BELOW GRADE WATERPROOFING PRE-CONSTRUCTION KICK-OFF MEETING

JOB NAME: Cora **JOB#** 201602
DATE: 5/11/2016 **TIME:** 10:00am

PROJECT INFO & APPROVED DETAILS:

Termination at Grade

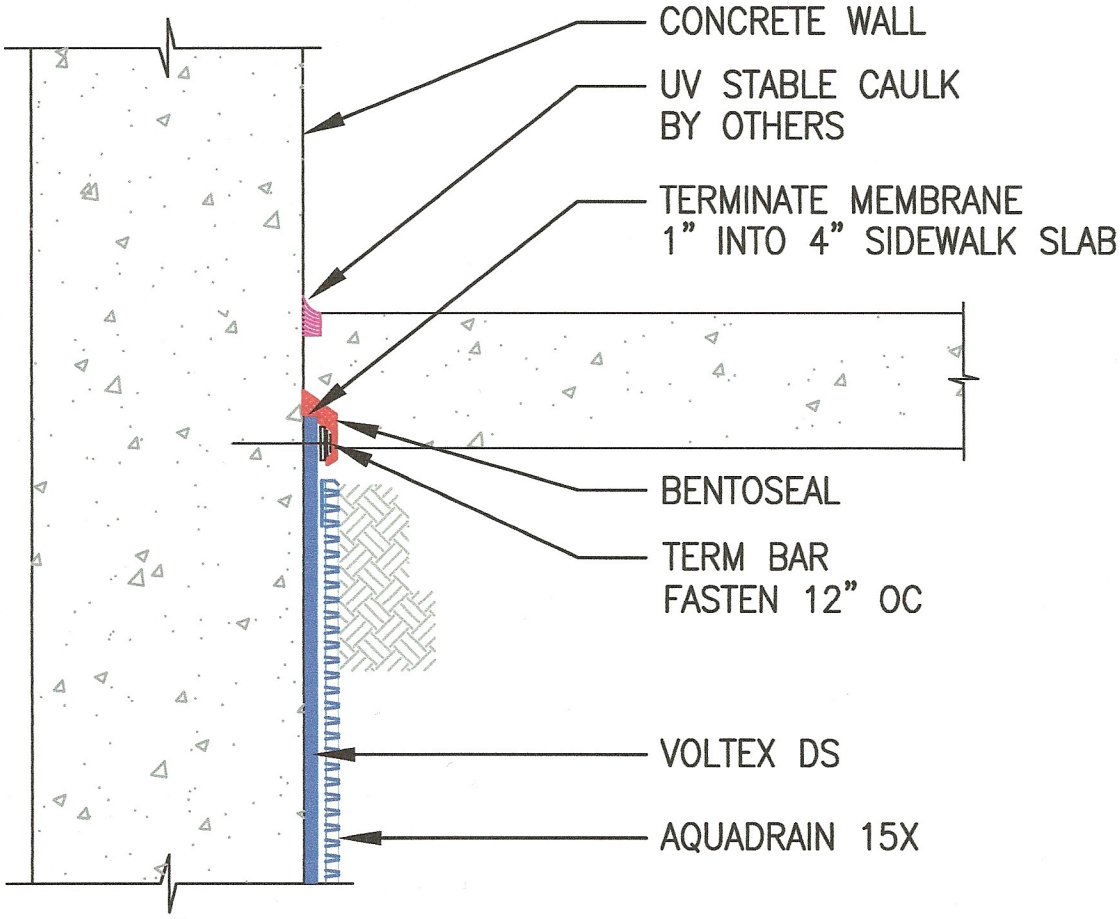
f) Clarify below grade termination details at grade:
   i. Detail 101/BE100. Discuss addition of flashing at grade. See also detail 104. Clarify where this occurs. VIA and Barrientos have stated that they do not want to take on the additional cost of flashing to conceal the below grade water proofing termination along landscaped areas.
   ii. Terminate bentonite in the sidewalk in lieu of below? Review detail 113/BE101. Yes, Termination should match Cetco standard detail showing the Voltex terminating 1" into the sidewalk. Exxel to confirm with RFI.

Backfilled Elevator Pit (Non-Hydrostatic)

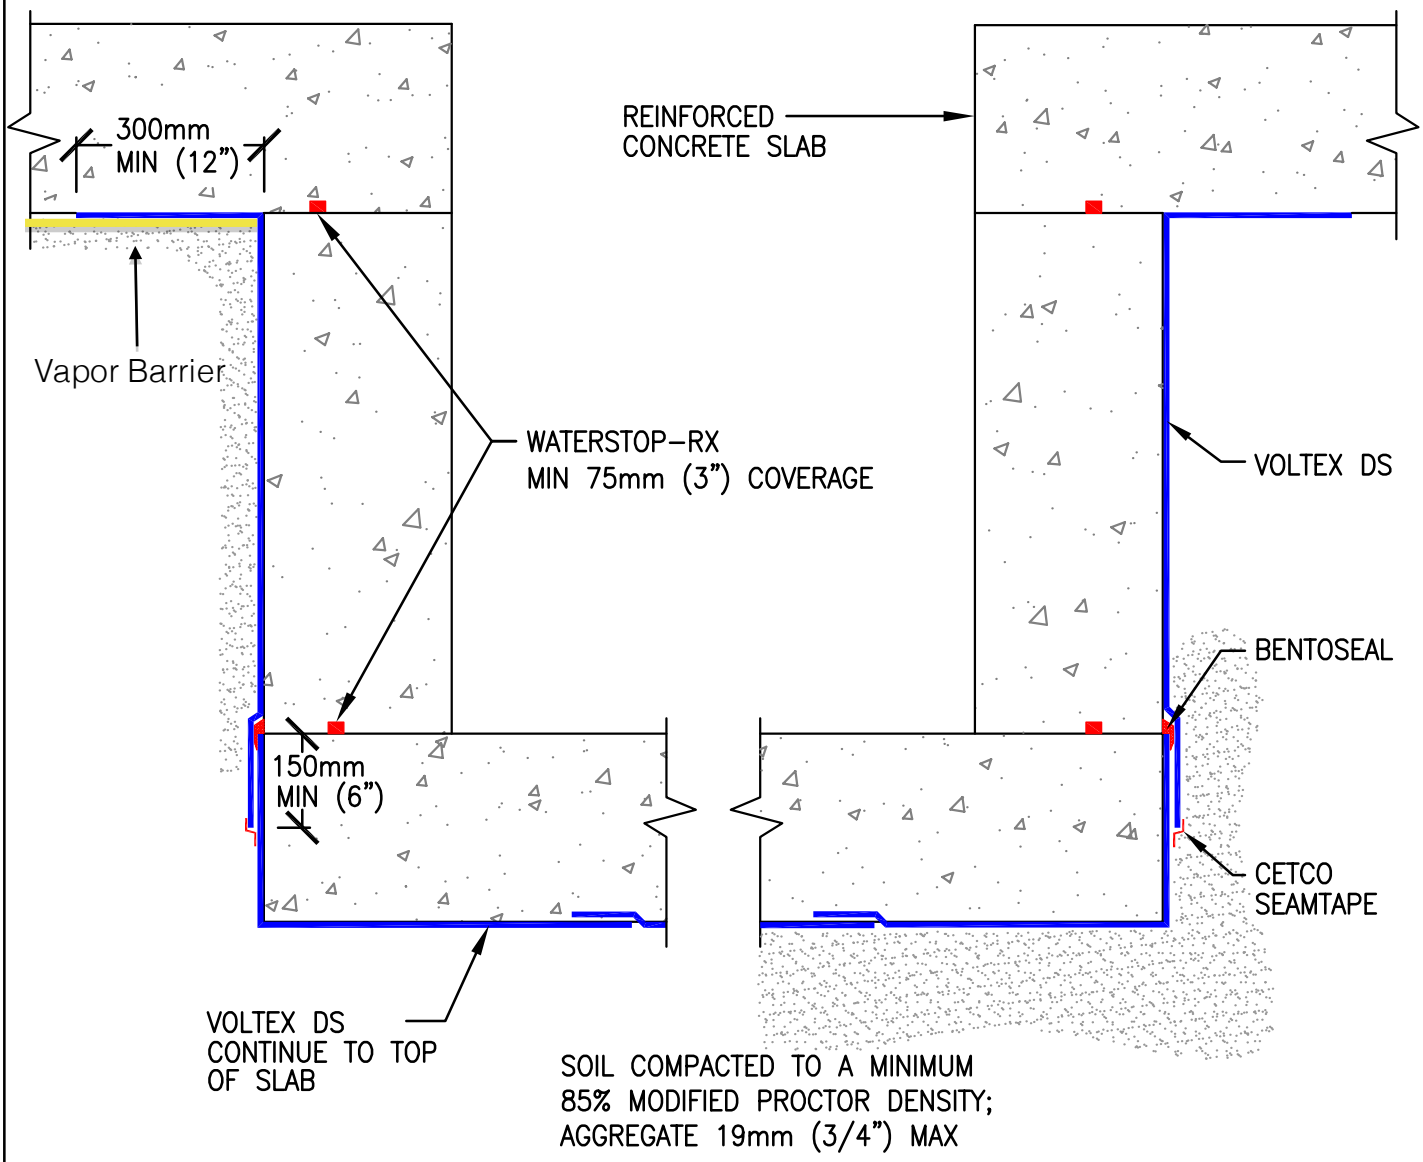
2. Review below grade waterproofing plan.
   a) Elevator pit waterproofing per 103/BE100. This detail will be revised in an upcoming RFI to reflect Cetco detailing.
      i. Where is the water table in relation to the bottom of the elevator pit? Pangeo has determined that the height of the water table is not a concern on this project.
      ii. Clarify elevator pit pour sequencing. Exxel will not be installing a rat slab under the elevator pit.
      iii. Discuss concrete mix and stingers. Consolidation is key.

e) Clarify vapor barrier scope:
   i. 100 and 103/BE100. Detail to be revised per RFI to match Cetco standard detail showing Voltex extending 12" horizontally over vapor barrier.

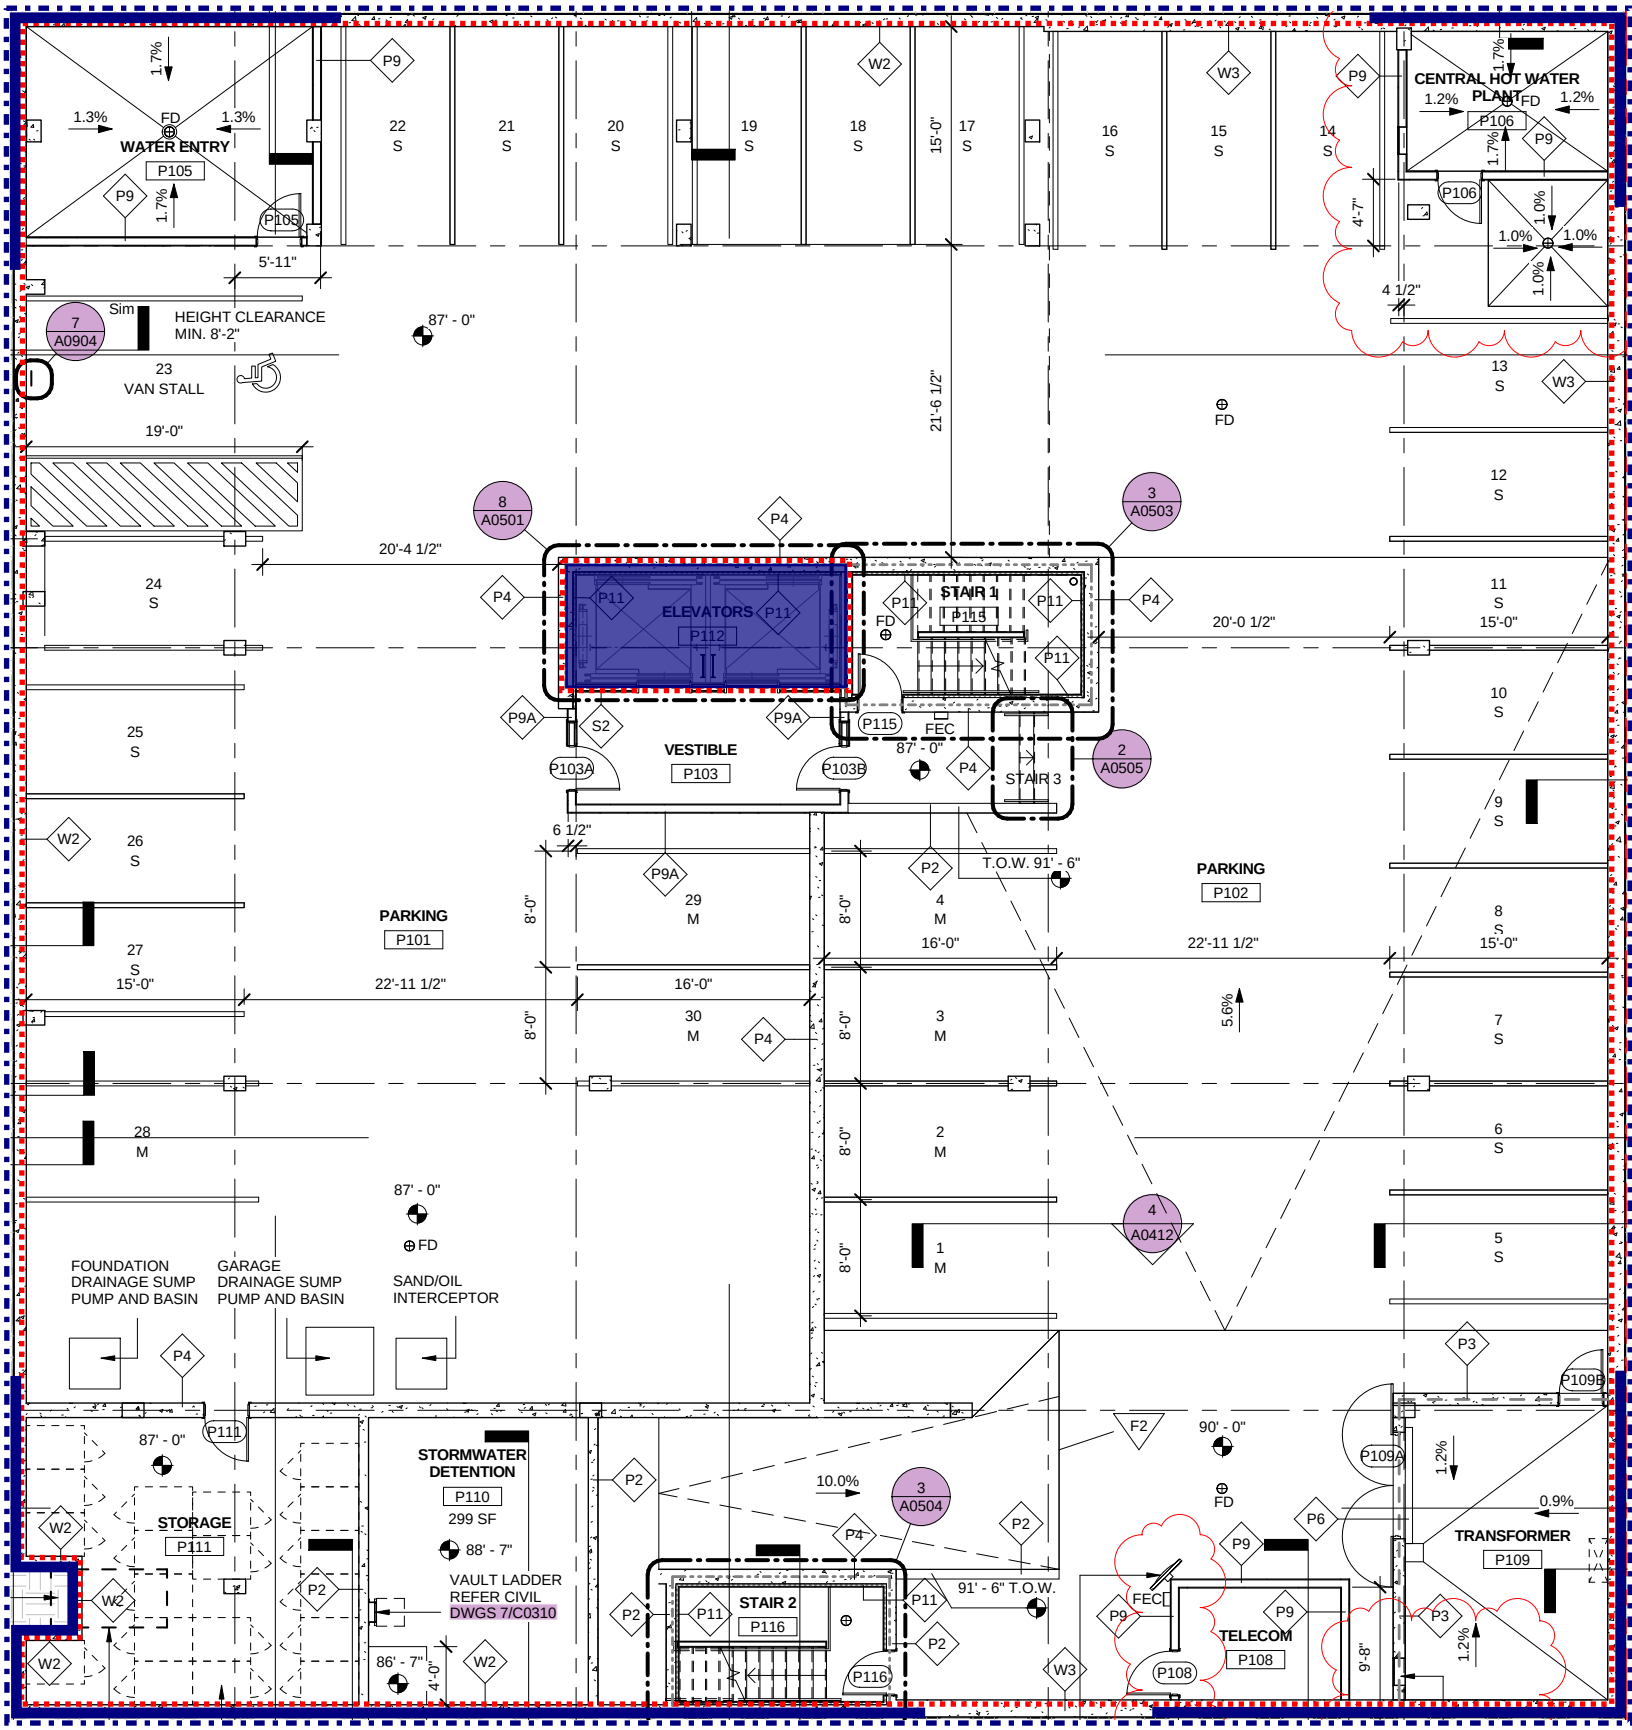
c) Voltex DS and drain mat areas. See below grade waterproofing zone layout sheets:
      i. Cetco requires foam or grout in shoring voids prior to pressure treated plywood.
      ii. Mark top of grade on H-piles prior to Sound WP starting work. Keep drain mat and Voltex DS 2" below this line. Who will mark grade? Exxel to mark grade.
      iii. Clarify tie-back waterproofing details.
         1. Block out size and material at Voltex: Boxes will be framed around tie backs at Voltex DS areas. Tie backs should be centered and boxes should be framed
